SUBJECT: RIVER BEND STATION, UNIT 1 - AMENDMENT NO. 31 TO FACILITY
OPERATING LICENSE NO. NPF-47 (TAC NO. 67878)

AMENDMENT TO FACILITY OPERATING LICENSE

Amendment No. 31
License No. NPF-47

ATTACHMENT TO LICENSE AMENDMENT NO. 31

FIGURE 3.2.1-1
MAXIMUM AVERAGE PLANAR LINEAR HEAT GENERATION RATE (MAPLHGR)
VERSUS AVERAGE PLANAR EXPOSURE BP8SRB094

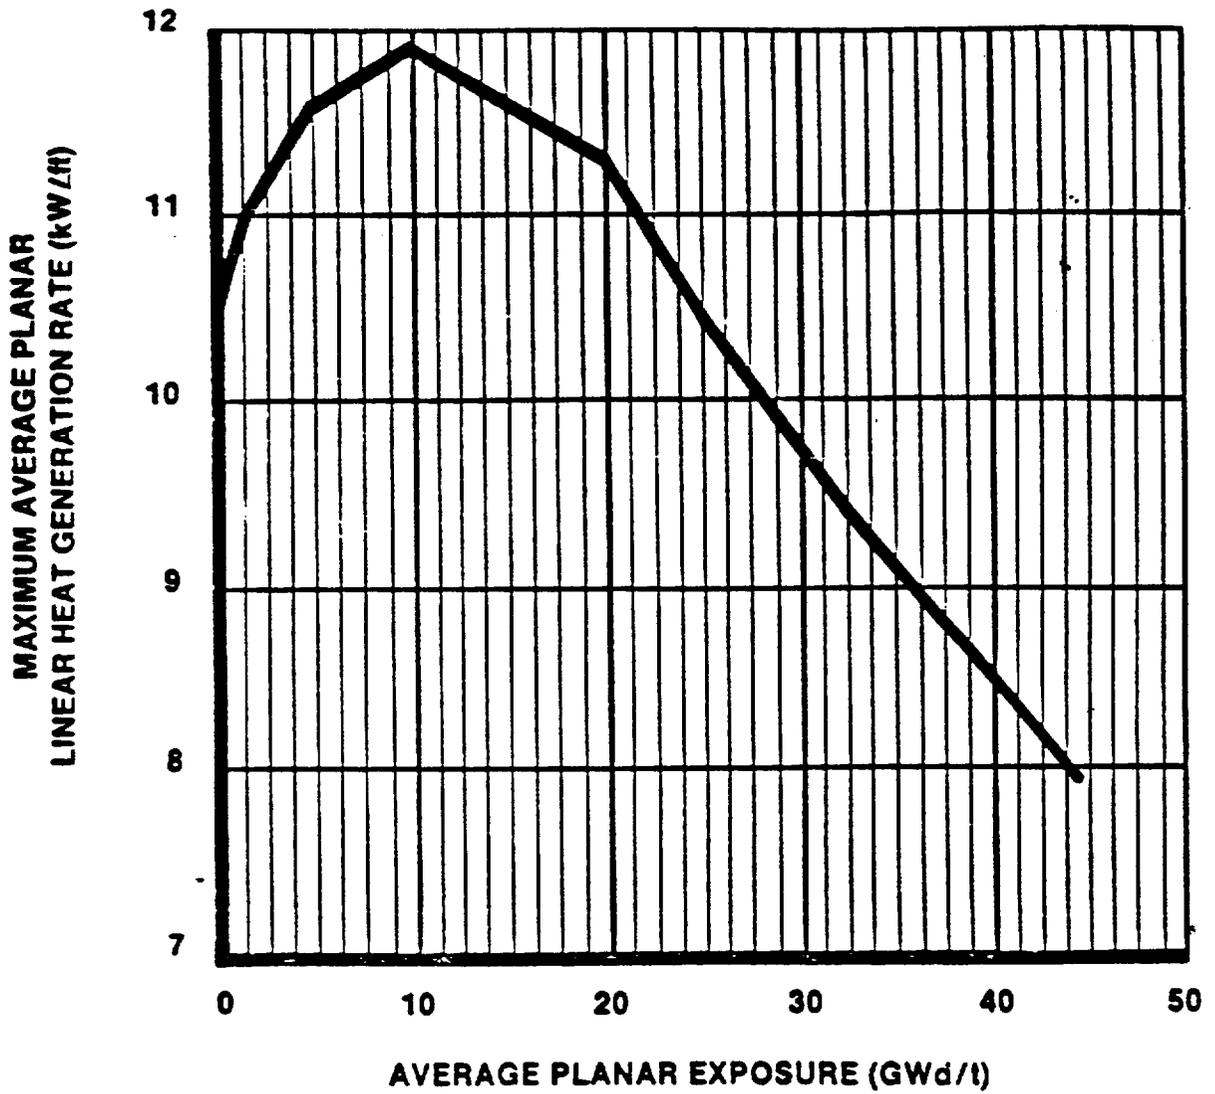
For plant operation with a single recirculation loop, the MAPLHGR limits of figures 3.2.1-1 through 3.2.1-6 are multiplied by 0.84. The constant factor 0.84 is derived from LOCA analyses initiated from single recirculation loop operation to account for earlier boiling transition at the limiting fuel mode compared to the standard LOCA evaluations.

3.2.1 All AVERAGE PLANAR LINEAR HEAT GENERATION RATES (APLHGRs) for each type of fuel as a function of AVERAGE PLANAR EXPOSURE shall not exceed the limits shown in Figures 3.2.1-1, 3.2.1-2, 3.2.1-3, 3.2.1-4, 3.2.1-5, and 3.2.1-6. The limits of Figures 3.2.1-1, 3.2.1-2, 3.2.1-3, 3.2.1-4, 3.2.1-5 and 3.2.1-6 shall be reduced to a value of 0.84 times the two recirculation loop operation limit when in single loop operation.

CORE FLOW (% RATED)
 FIGURE 3.4.1.1-1
 THERMAL POWER VERSUS CORE FLOW

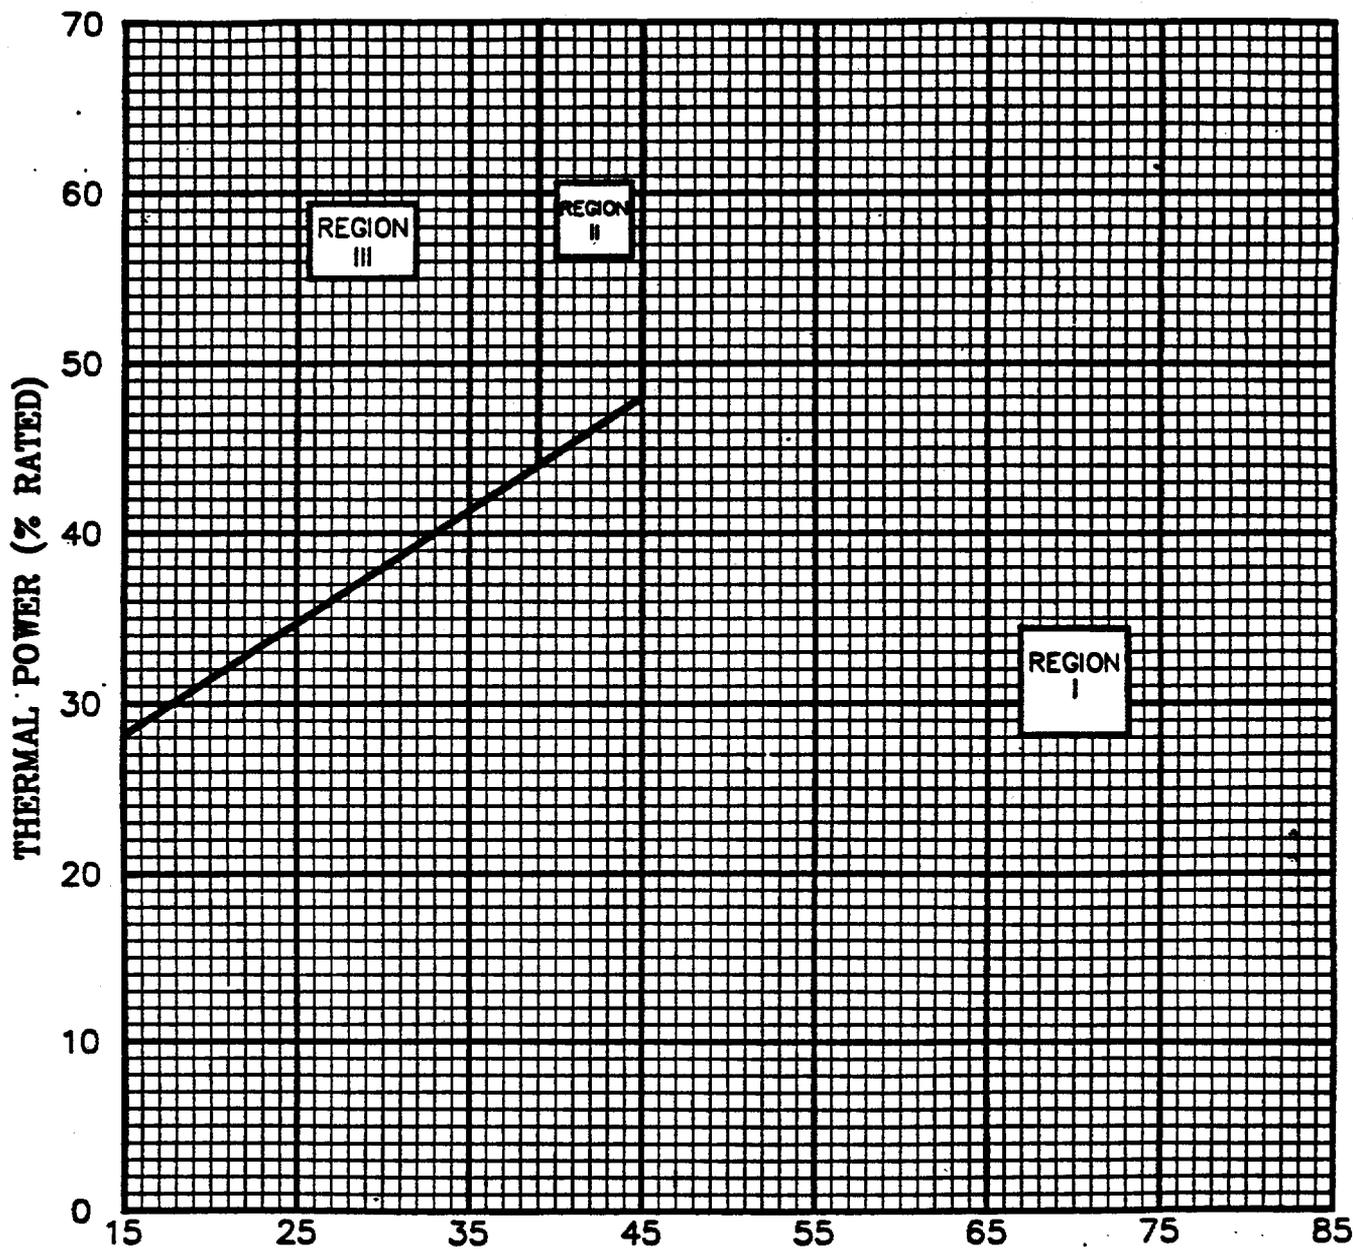
The Technical Specifications related to the Recirculation Loops are modified to reflect single-loop operation considerations discussed in this Safety Evaluation. This includes replacement of Figure 3.4.1.1-1 to identify the detect and suppress regions of the power-flow map associated with thermal-hydraulic stability.

3.4.1.1 The reactor coolant system recirculation loops shall be in operation and in Region I as specified in Figure 3.4.1.1-1 with either:

- g. With one or two reactor coolant system recirculation loops in operation and total core flow greater than 39% and less than 45% of rated core flow and THERMAL POWER greater than the limit specified in Region II of Figure 3.4.1.1-1:

- h. With one or two reactor coolant system recirculation loops in operation and total core flow less than 39% of rated core flow and THERMAL POWER greater than the limit specified in Region III of Figure 3.4.1.1-1, immediately within 15 minutes initiate corrective action to increase core flow to greater than or equal to 39% of rated core flow or reduce THERMAL POWER to less than the limit specified in Region III of Figure 3.4.1.1-1 within 4 hours.
